GULF STATES UTILITIES COMPANY

River Bend Station
Docket No. 50-458/Unit 1
Docket No. 50-459/Unit 2

RBS ER-OLS

QUESTION E290.8

FIGURE 3.5-2
RADIOACTIVE LIQUID
WASTE SYSTEM
RIVER BEND STATION
ENVIRONMENTAL REPORT - OLS

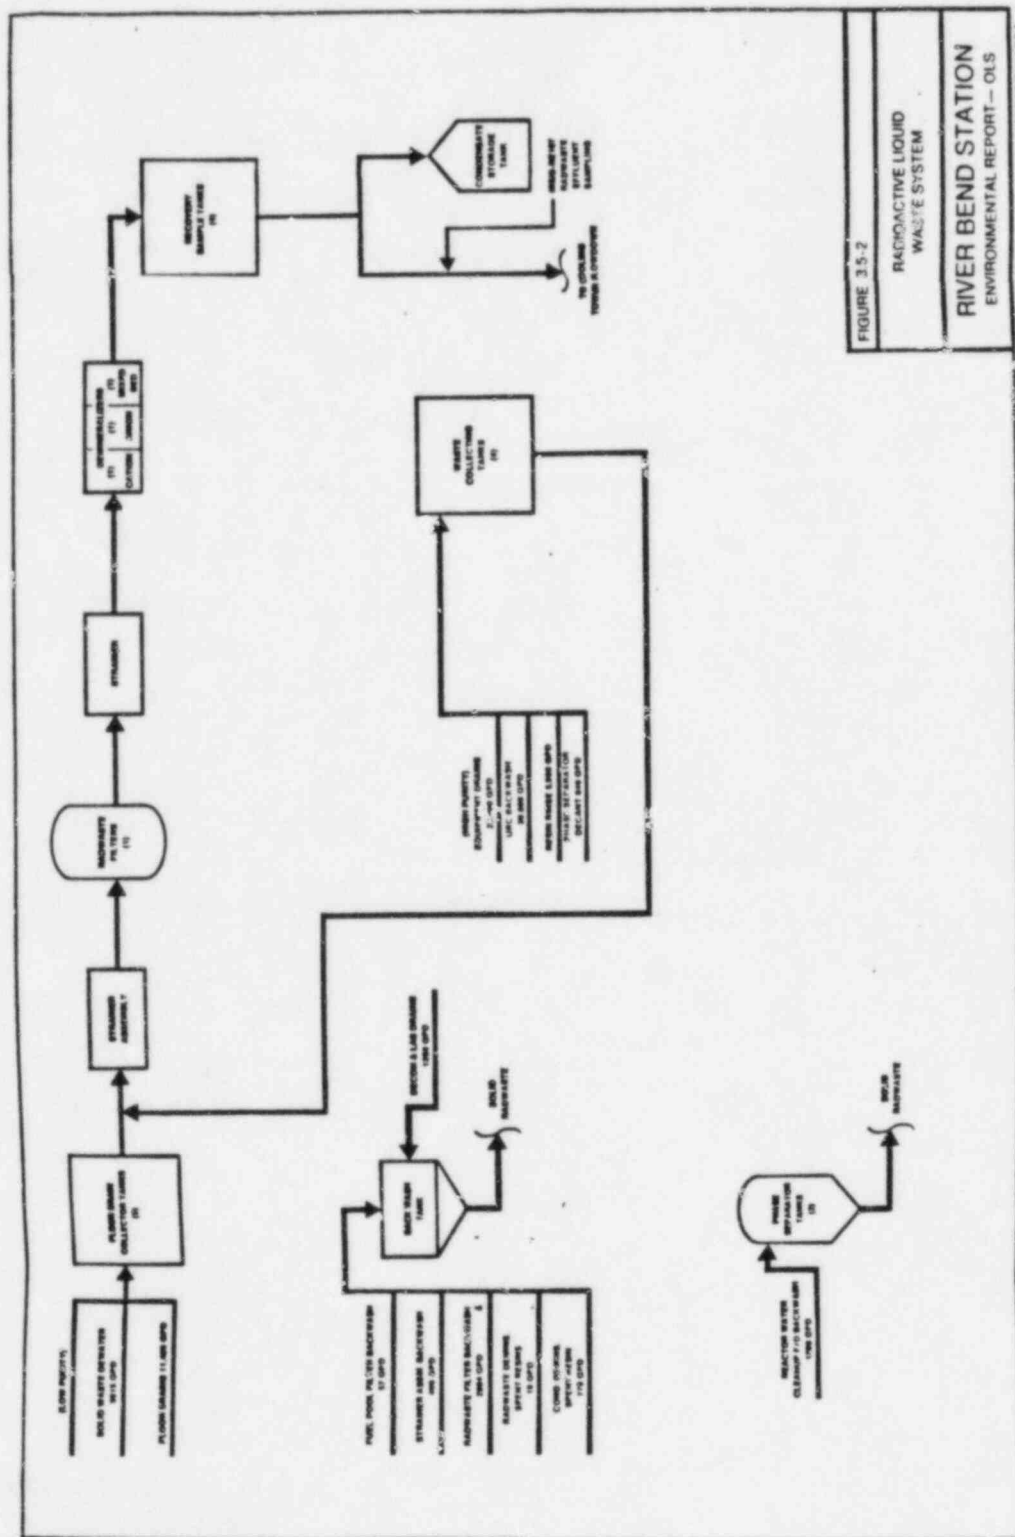
3.5.3.2 System Description	1.38
The system is divided into one minor and one major subsystem	1.39 7
so that the liquid wastes from various sources can be	1.41
segregated and processed separately. The segregation is	1.44
done according to the liquid conductivity and/or	
radioactivity. All collection tanks, pumps, and processing	1.46 7
equipment are located in the radwaste building. Major flow	1.48
paths, equipment data, leakage, and drainage are indicated	
on Fig. 3.5-2. Refer to Table 3.5-4 for a summary of design	1.50
parameters for the liquid radioactive waste systems.	1.52

3.5.3.2.1 Waste and Floor Drain Collector Subsystem	1.54 7
Wastes entering the waste collector tanks have variable	1.56 7
activity levels depending on their source and relatively low	1.58
conductivity (less than 50 umho/cm). There are four waste	2.1
collector tanks to receive liquid waste from designated	2.2
systems within both units. Radioactive materials are	2.3
removed from these wastes by filtration (insolubles and oil	2.4
removal) and ion exchange (soluble and colloidal removal).	2.5
